February 1, 2013  
RC-13-0017

Subject: VIRGIL C. SUMMER NUCLEAR STATION (VCSNS) UNIT 1  
DOCKET NO. 50-395  
OPERATING LICENSE NO. NPF-12  
LICENSE AMENDMENT REQUEST – LAR-06-00055  
LICENSE AMENDMENT REQUEST TO ADOPT NFPA 805  
ADDITIONAL INFORMATION REGARDING RESPONSE  
TO REQUEST FOR ADDITIONAL INFORMATION

**Probability Risk Assessment Additional Information**

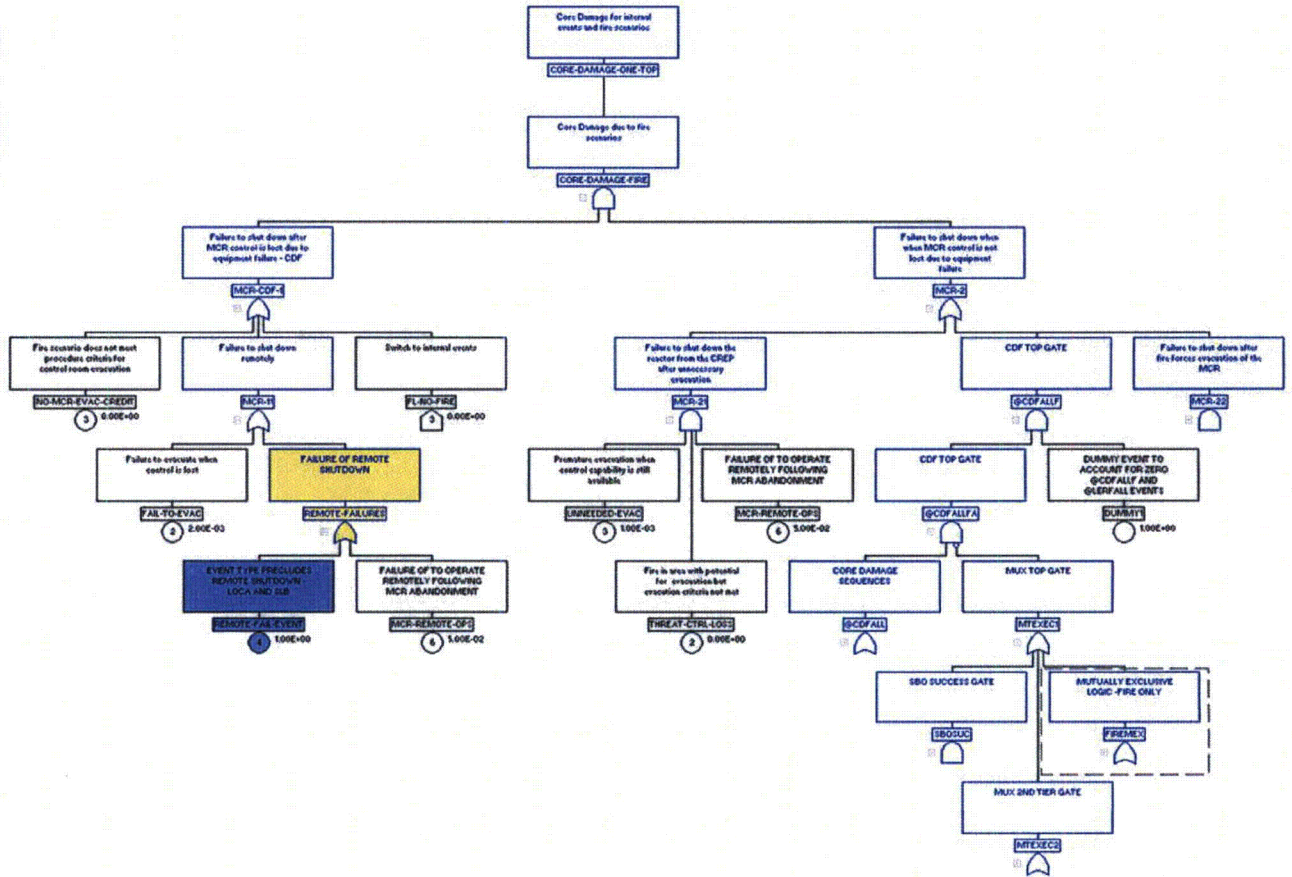
FSS-B2-01: It is not clear from the MCR abandonment document what the criteria are for CR abandonment for main control board (MCB) fires. Secondly, from the MCB scenarios the conditional core damage probability (CCDP) does not appear correct for the specified number of panels as given in Appendix B of the Fire Risk Quantification Task 14 document. For example, for scenario CB 17.01 MCB 11-10-1, 11-9-1, and 11-8-1, 2, 3, and 4 panels are failed respectively, yet the CCDP from the quantification document specified that the CCDP is largest when only 2 panels are damaged. Also for scenarios CB17.01 MCB 18-18-1, 18-17-1, 18-16-1, and 18-15-1 the CCDP is the same for each scenario even though 1, 2, 3, and 4 panels are damaged respectively. Provide the criteria for CR evacuation for MCB fires, and justify the CCDPs provided for the various number of panels damaged. The response should take into account a further examination of the CCDPs for MCB fires than identified in this question to evaluate if the CCDP problem is more extensive than discussed in this question. Provide updated CDF, LERF,  $\Delta$ CDF, and  $\Delta$ LERF values for MCB scenarios.

The CCDP issue was an error in the model that was due to the FRANX software treatment of mutually exclusive events. The top logic structure of the fault tree (shown below) includes NOT logic that removes cutsets associated with mutually exclusive events. When the FRANX model sets the failures associated with the fire, it sets all of the failed events to TRUE and then compresses the tree and solves it. If two events are mapped to a scenario that appears in the mutually exclusive logic gate (FIREMEX), the gate @CDFALLF is set to FALSE. This means that only the MCR abandonment logic is considered for the scenario. This was the root cause of the issue that resulted in abnormal CCDP results for the main control board scenarios. The model has been updated to address this issue and the updated results for the MCB scenarios are listed in the table below including CDF, LERF,  $\Delta$ CDF and  $\Delta$ LERF.
